Response to Reviewer #1 comments

In the paper entitled “Performance of the Adriatic Sea and Coast (AdriSC) climate component – a COAWST V3.3-based coupled atmosphere-ocean modelling suite: atmospheric part” the Authors introduce and analyze the performances of the atmospheric compartment of the AdriSC coupled model. The paper is interesting and opens the door to some new important development in the Mediterranean modeling community.

Response to Reviewer #2 comments

Figure R1. Seasonal variations of the median hourly temperature bias between AdriSC WRF 3-km model results and NOAA land station measurements during winter (DJF), spring (MAM), summer (JJA) and autumn (SON) for the 1987-2017 period.

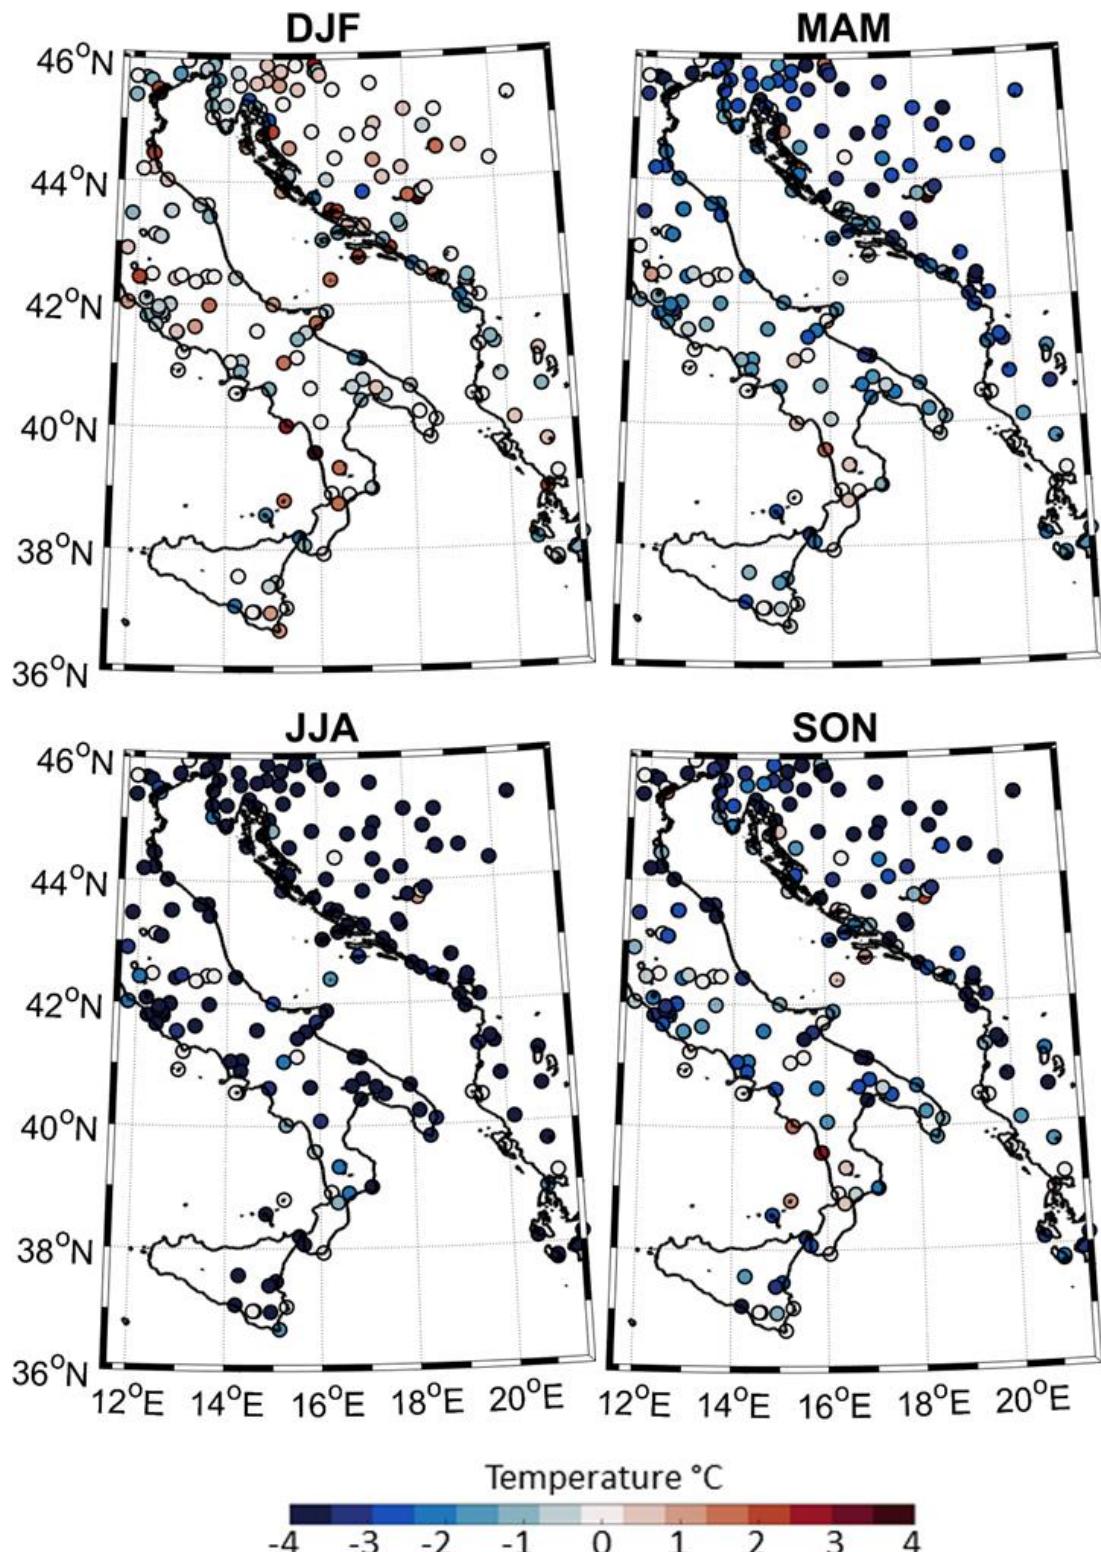
- *Fig.12 -Fig. 15 I would color both land and sea in white and leaves in black only the coastlines: the marker line of each dot can be also done in black*

Response: The suggestion of the reviewer was implemented in Figure R1 (see below) for the 2 m air temperature, as an example. The authors believe that the obtained figure looks extremely empty and is overall more difficult to read due to a lack of contrast which is not present in the original figures. Consequently, the authors kept Fig. 12 to 15 as presented in the original version of the article.

Figure R2. EOF analysis (three first components) of the sea-surface height extracted from MEDSEA for the 1987-2017 period.

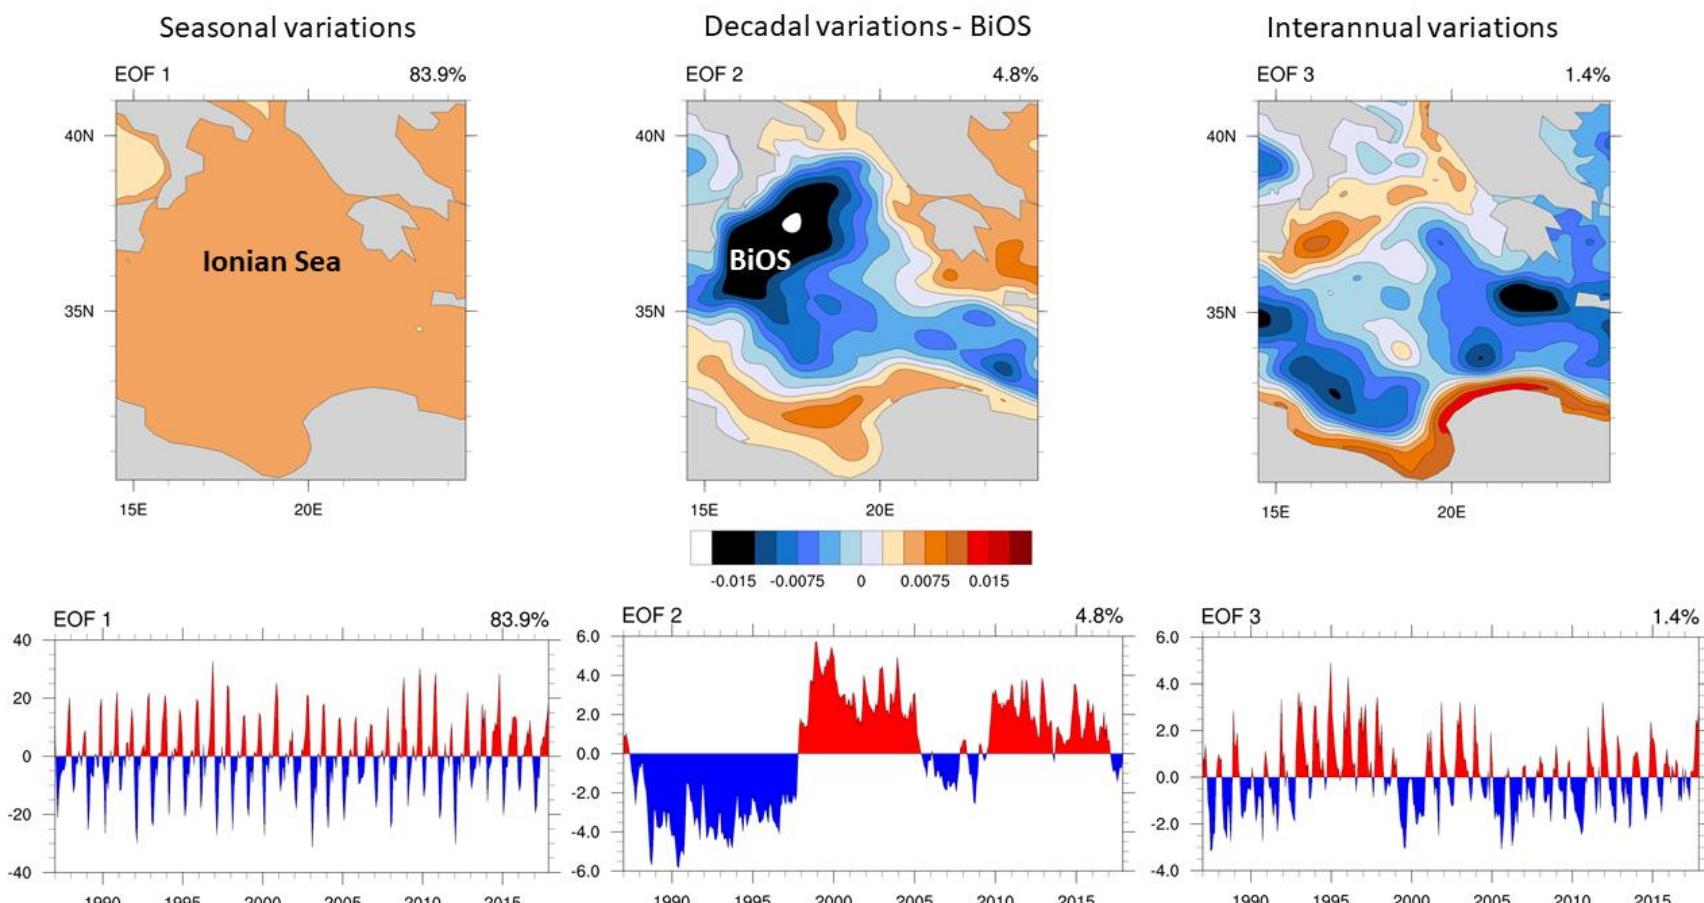
- *Line 558-560 (and after) I would be a little bit careful with that. As far as I remember Theocharis et al., 2014, Reale et al., 2016 and Reale et al., 2017 discussed the necessity of the inclusion of the Aegean Sea in the Adriatic Ionian to explain the BiOS variability... I should discuss that in the sentence. Moreover, does it mean that you plan to include also the Aegean Sea in your modeling domain? Do you expect that the MEDSEA (which provide the BCs in the ocean model) reanalysis include the BiOS signal? Did you check that?*

Response: Yes, the authors have checked that the BiOS is reproduced by the MEDSEA re-analysis. Gačić et al. (2011) have demonstrated that the BiOS is well described with the decadal change of sign of one of the main components of the EOF derived from sea-surface height. Figure R2 (see below) is indeed showing the EOF analysis (3 first components) of the sea-surface height extracted for 1987-2017 period within the Ionian Sea. The BiOS is also seen by the ROMS 3-km ocean model used in the AdriSC climate model and the results will be soon submitted by Pranić et al. (2021) to GMD. However, the authors would agree with the reviewer that the BiOS is located a bit too close to the southern open boundary of the AdriSC WRF/ROMS 3-km grids and will be influenced by the MEDSEA forcing in the AdriSC climate model. Nevertheless, the authors also believe that they can still use the 31-year AdriSC 3-km results to look at the drivers of the BiOS particularly to confirm whether this driver is the dense water coming from the Adriatic Sea.

The sentence was reformulated as follow:

“Additionally, as the MEDSEA re-analysis captures the BiOS signal within the Ionian Sea (e.g. Pinardi et al., 2015), the inclusion of the Aegean Sea suggested by Reale et al. (2017) is not necessary if MEDSEA is used as a forcing. Consequently, the AdriSC climate model has also been developed with the aim to expand the knowledge on whether the Adriatic dense waters travelling towards the Ionian Sea can be an important driver of the BiOS.”
